**Re: Submission / Observation on planning reference number: ACP 324155-26
Proposed Cahermurphy West Windfarm Development**

Figure 2: Population viability of Irish Hen Harrier breeding areas

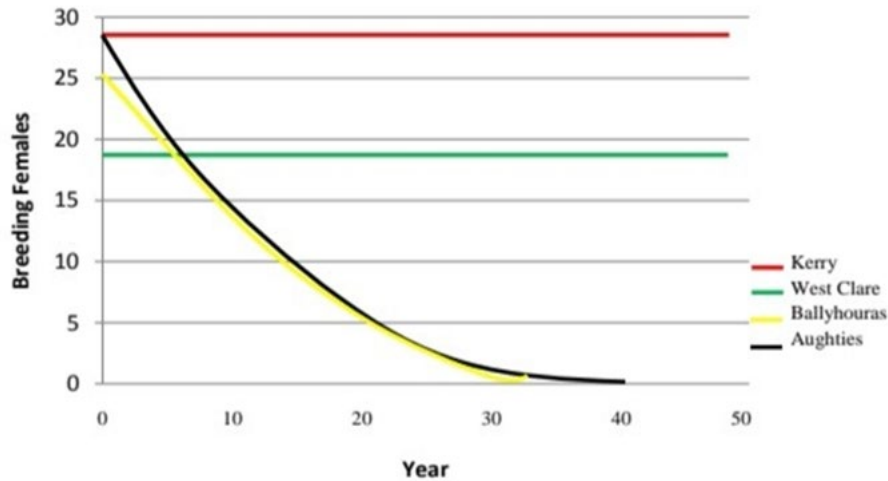
Barry O'Donoghue published '[The Ecology and Conservation of Hen Harriers in Ireland](#)' in 2010. In the report he predicted that the number of breeding females in the West Clare area would remain the same (see graph below), however in the 2015 national survey there was sharp decline of breeding hen harrier recorded in West Clare. It could be argued that this decline aligns with the erection of over 100 wind turbines in the North and West Clare territory.
